## **REQUEST FOR PROPOSALS No. 26-027**

### **Hallberg Playground Design-Build**

**Addendum 1 (6 pages)**

**Issued: June 18, 2026**

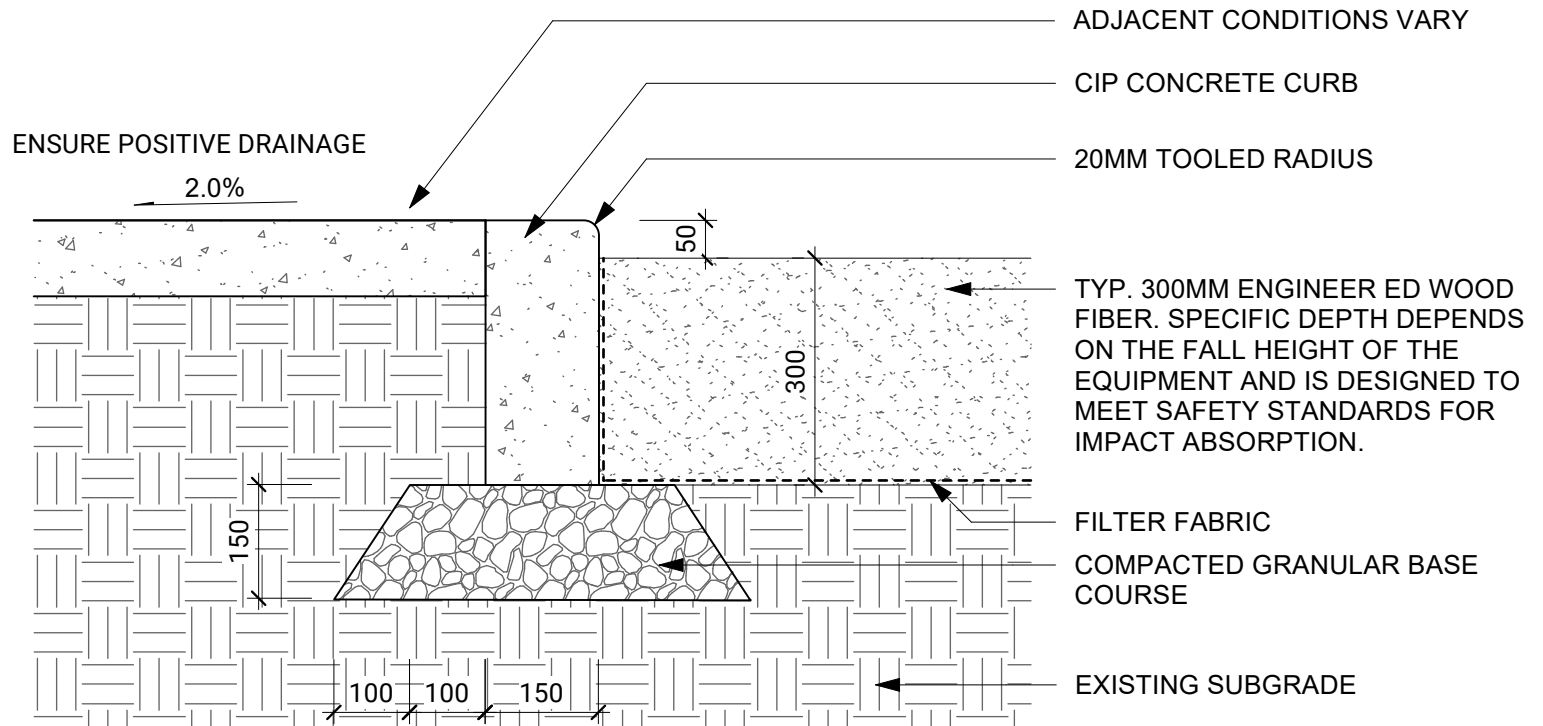
DELETE: ED-03 Edge 03 - Concrete Ramp and Rubber Pathway

ADD: Revised ED-03 Edge-03 - Concrete Ramp attached herein.

**Q3.** What is the rubber pathway detail pertaining to? I don't see any rubber in the materials.

**A3.** There is no rubber play / safety surfacing being considered for the playground. Please replace detail ED-03 Edge 03 - Concrete ramp and rubber pathway with revised ED-03 Edge-03 Concrete Ramp.

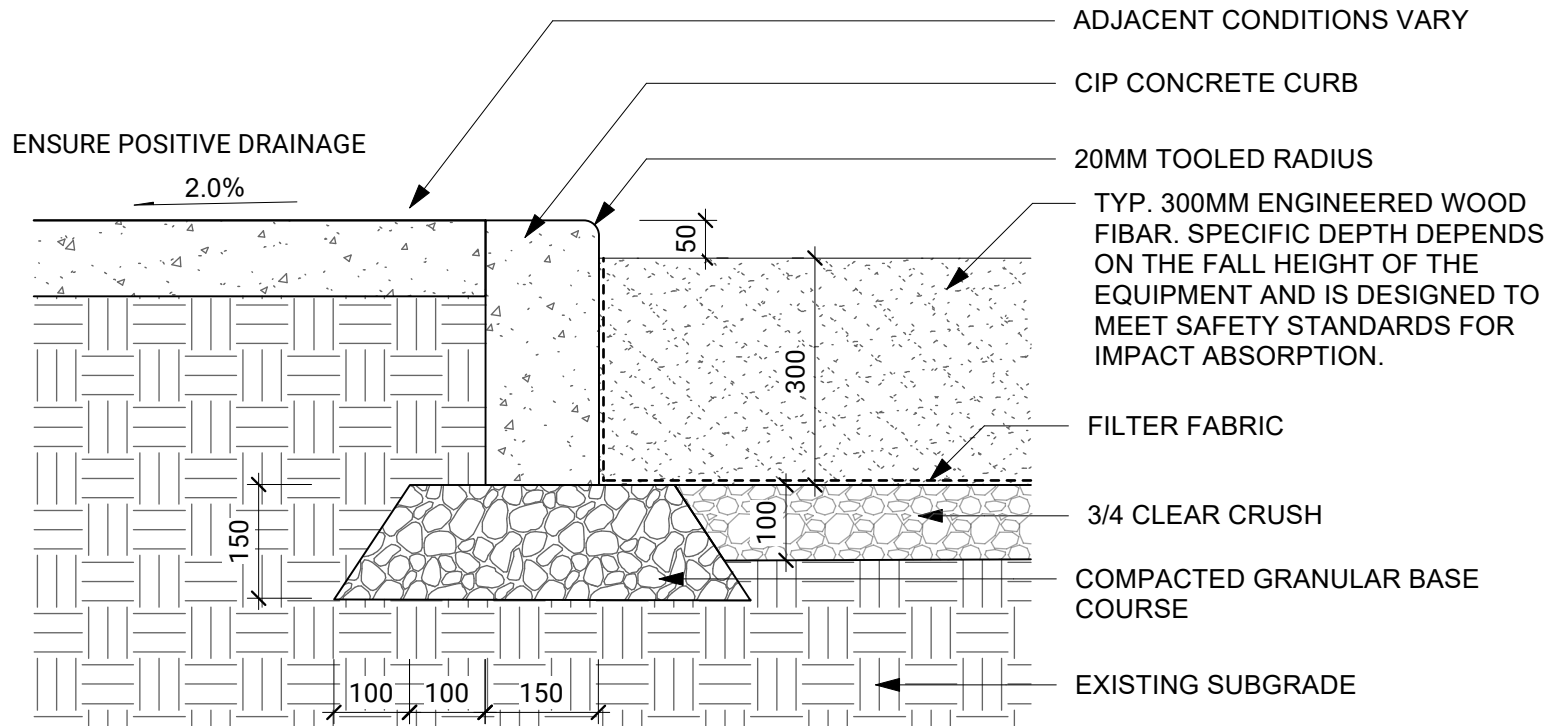
ADD: Appendix 3: HS-06, Hardscape 06 - Wood Fiber attached herein.

**Q5.** Who will be responsible for connecting the drainage pipes under the playground to the main outflow pipe?

**A5.** There are currently no plans to install subsurface drainage pipes connected to the surrounding stormwater system. At time of subgrade preparation, contractor to slope subgrade East as per Drawing L2.0 and install 4 inch (100mm) of 3/4 crush under Engineered Wood Fiber and filter fabric. See Detail HS-06 attached.
